UNITED STATES PATENT AND TRADEMARK OFFICE

10/731,210

Office Action Summary	Application No. 10/731,210	Applicant(s) BARKER ET AL.	
	Examiner JAMES L. SWIGER	Art Unit 3733

DETAILED ACTION

Fig. 1

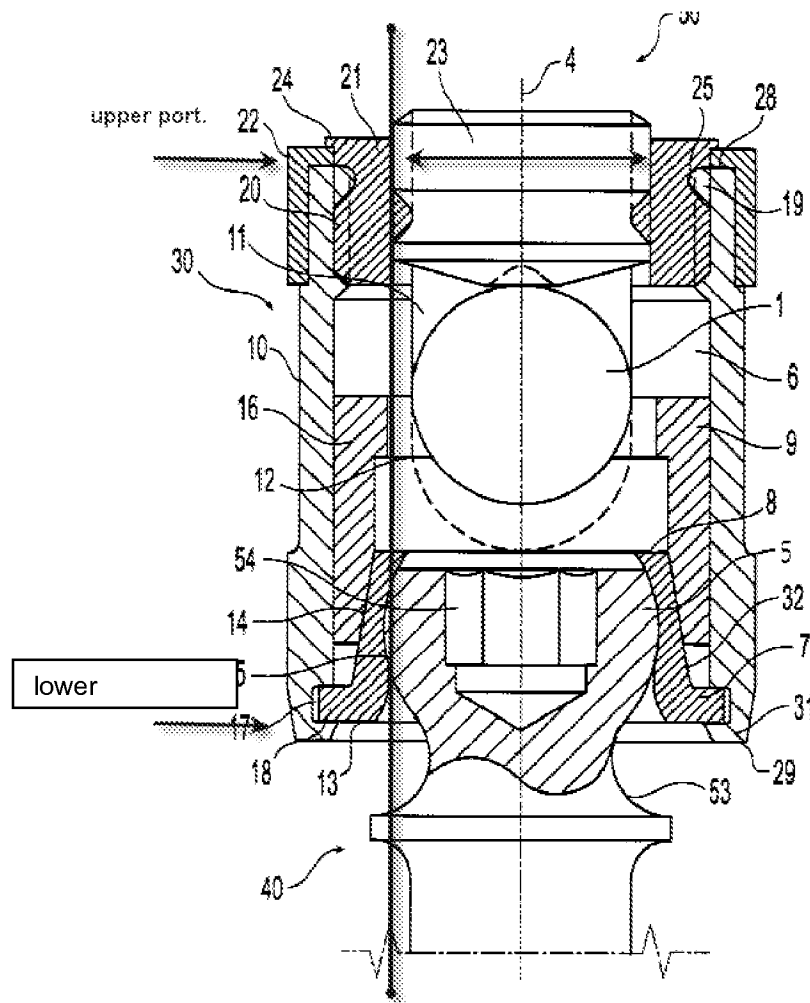
Claims 44-47, 49-52, 54-57, 70-72, and 74-77 are rejected under 35 U.S.C. 103(a) as being unpatentable over Schlapfer et al. (US patent 6, 248, 105) in view of Lombardo (US Publication 2001/0001119). Schlapfer et al. disclose a medical implant apparatus comprising a receiver member (30) having a longitudinal axis (4), an upper portion and lower portion (see drawing below).

Schlapfer also disclose a transverse channel and a longitudinal member occupying this space (1) an interior groove (17) that is substantially perpendicular to the axis, a retaining member (7) that also has an inner and outer dimension and wherein the retaining member occupies the groove (17) and is considered substantially circular and may be considered planar in one perspective, and may be fixed from radial movement depending on how the device is used. Schlapfer further comprises a bone anchor having a head (5) that fits within the receiver member, which is considered

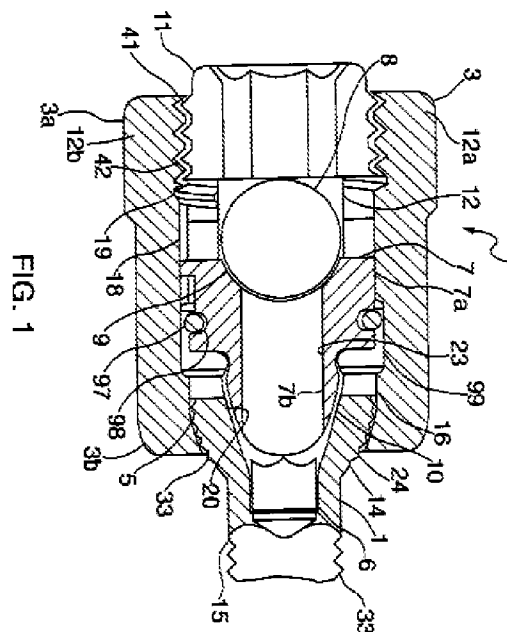
substantially between the retaining member (defined at lower portion and between upper portion). The groove communicates with the lower opening the retaining member substantially surrounds a part, or neck of the bone anchor. Also disclosed is a closure member (23) which assists in maintaining a closed or locked position of the apparatus. It is further noted that Schlapfer discloses an inner crest diameter (shown in drawing as double-sided arrow) which further defines a width which is comparatively smaller than a lower portion diameter. Note line drawn in figure. At least a portion of the retaining member may be considered a crown to be part of the head of the bone anchor.

Schlapfer discloses the claimed invention except for the upper opening having internal threading and also a set screw which secures and cooperates with threads and secures the device. Lombardo (see below)

discloses a medical fixation apparatus that has an upper opening (between 3 and 3a) having internal threading (42) and also a set screw (11) which secures and

cooperates with threads and secures the device. These features help to secure a rod or longitudinal member in place during the placement of the device for more precise level of fixation. It would have been obvious to one having ordinary skill in the art at the time the invention was made to construct the device of Schlapfer et al. having at least the upper opening having internal threading and also a set screw which secures and cooperates with threads and secures the device in view of Lombardo to better secure and set the device during surgery.
